**Southern Nuclear  
Operating Company, Inc.**  
40 Inverness Center Parkway  
Post Office Box 1295  
Birmingham, Alabama 35201

**Joseph M. Farley Nuclear Plant Units 1 and 2  
Request to Revise Service Water Intake Structure  
Exemption from Fire Protection Requirements at Farley Nuclear Plant**

Attachments: A – Overview of Current SWIS Exemption  
B – Detailed Description of Exemption Revision Request  
C – Adequacy of Safety Finding Under NFPA 805

**Figure B-1 – Farley SWIS Fire Area 72 – Simplified Layout**

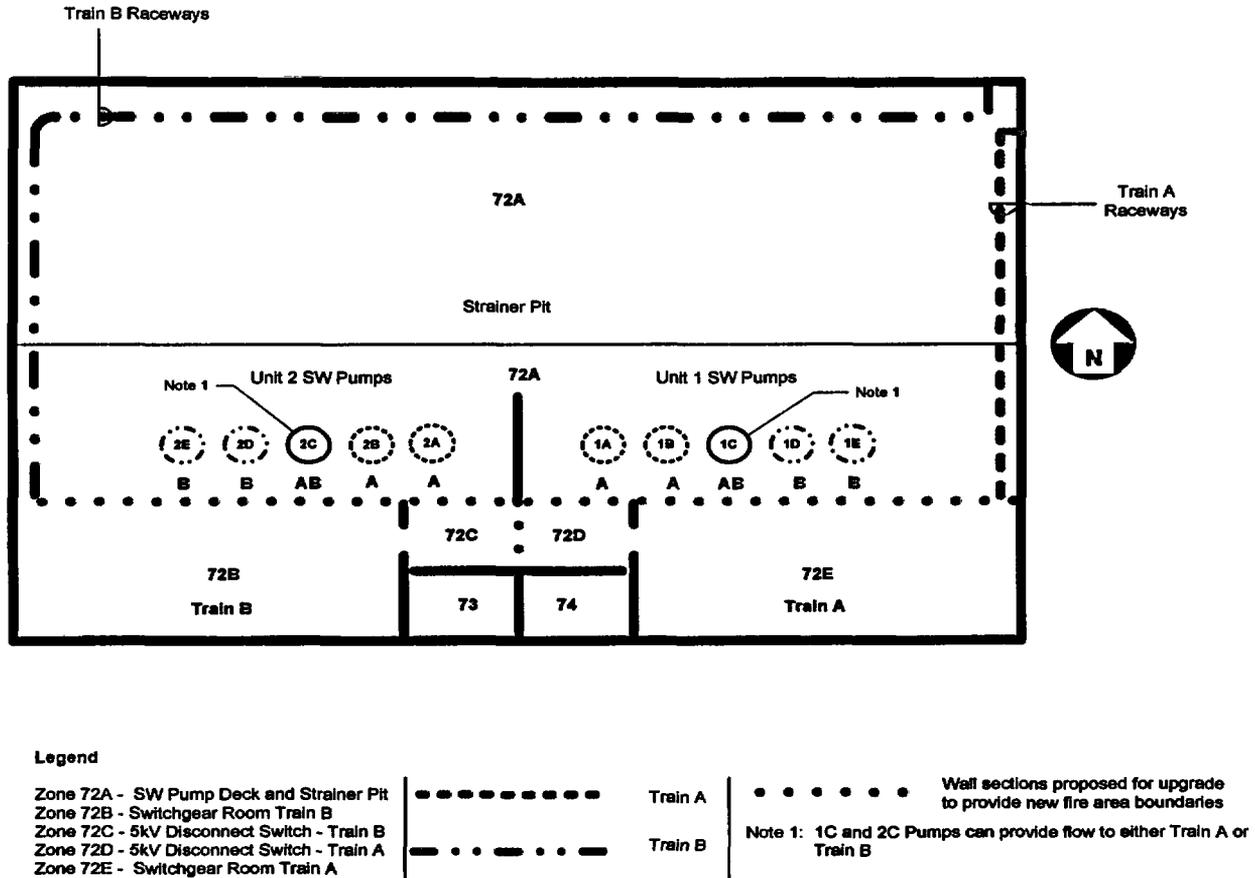
As shown in Figure B-1, most of the SWIS is designated as Fire Area 72. Fire Area 72 is comprised of five fire zones:

- Zone 72A – Service Water Pump Deck and Strainer Pit
- Zone 72B – Switchgear Room Train B
- Zone 72C – 5kV Disconnect Switch – Train B
- Zone 72D – 5kV Disconnect Switch – Train A
- Zone 72E – Switchgear Room Train A

SNC also intends to upgrade the nominal 18-inch concrete wall between Fire Zone 72A and Fire Zones 72B, C, D and E to meet the requirements of FNP's Fire Protection Program for a minimum 3-hour fire area boundary. Penetrations will be sealed, un-rated doors will be replaced by 3-hour rated fire doors, and three new fire areas will be created, 72A, 72B/72C and 72D/72E. These changes will provide cost-effective improvements in fire safety and will eliminate potential fire propagation paths between the pump deck and switchgear rooms, as well as between redundant switchgear rooms. These changes will provide additional defense-in-depth, supporting the elimination of the need for Kaowool barriers in fire area 72A because cables in that fire area will be protected from fires in fire areas 72B/72C and 72D/72E by the passive features of the upgraded wall.

In addition, a new curb on the Unit 1 pump deck will be installed to prevent liquid spill fires associated with the Unit 1 pumps from pooling beneath the Train A cable tray located near the east wall.
